Parramatta North Urban
Transformation
Draft State Environmental Planning Policy
(PNUT) 2014

Response to
Submissions

9 June 2015

PROPOSED_MAXIMUM HEIGHT

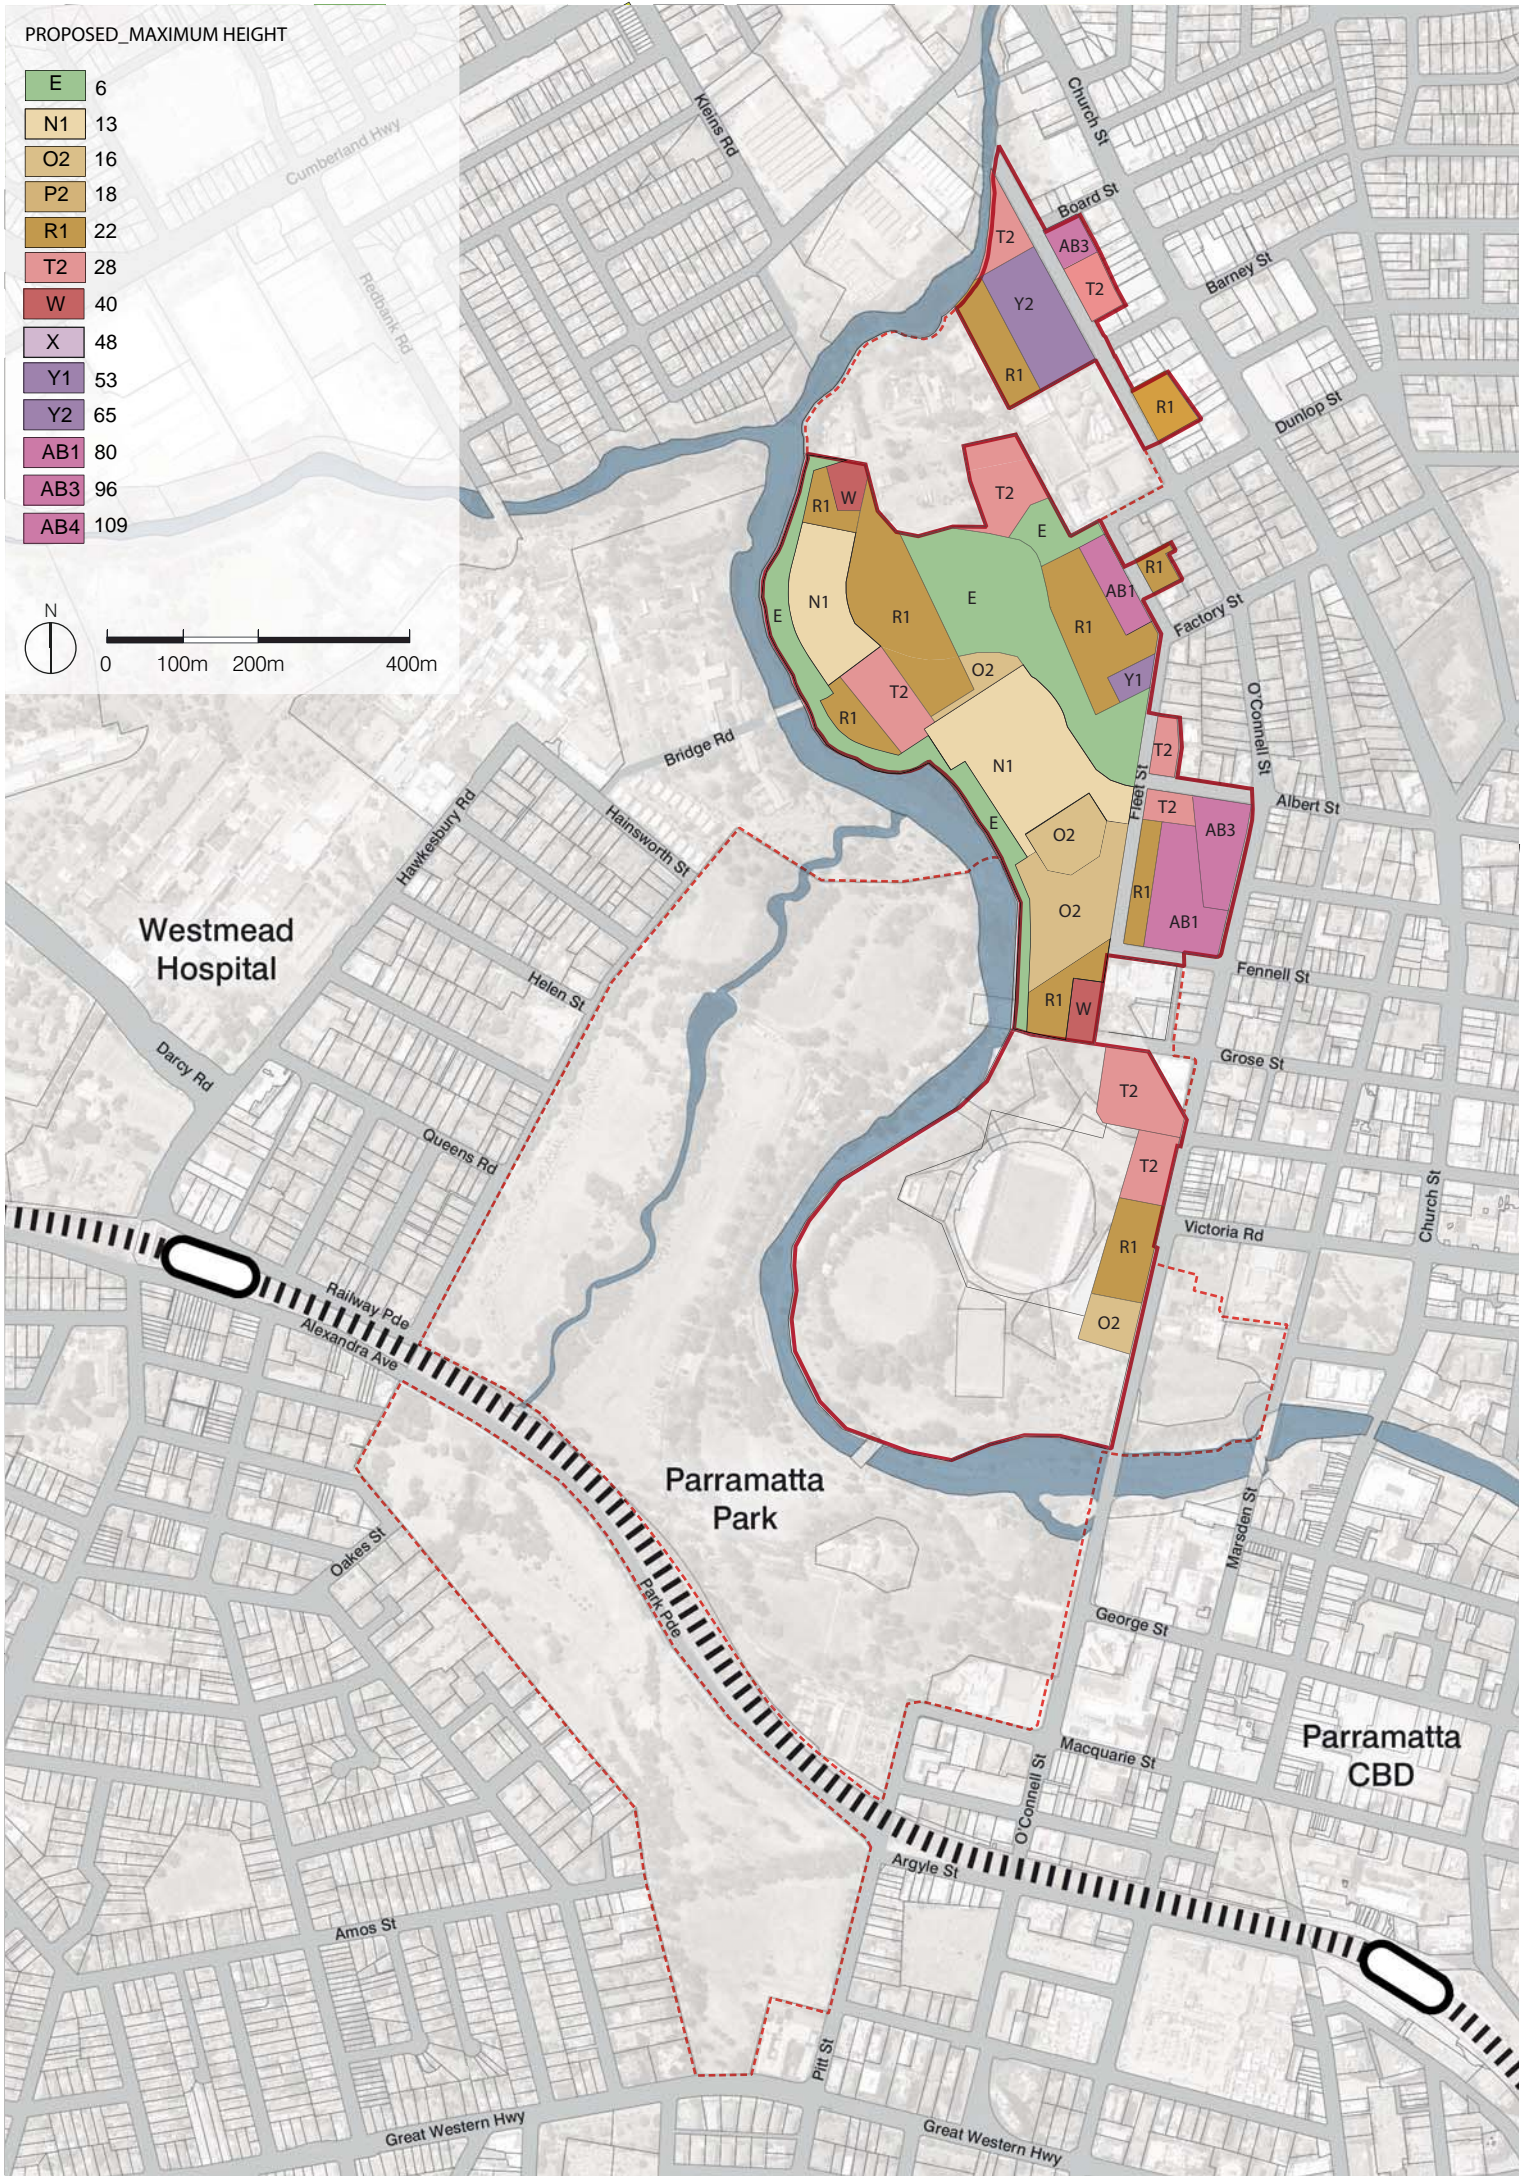
Building heights should not be imposed on proposed RE1 Public Recreation land	<p>The amended Height of Buildings map applies a 6 metre maximum height limit on any land proposed to be zoned RE1 Public Recreation.</p> <p>Building heights will continue to apply to the location of future roads consistent with the practice of the current height designations and planning for englobo land.</p>

Consequential amendments to the draft Land Zoning map and Height of Buildings map have been made and reflected the ILP revision. These amended draft LEP plans are included at Attachment 2.
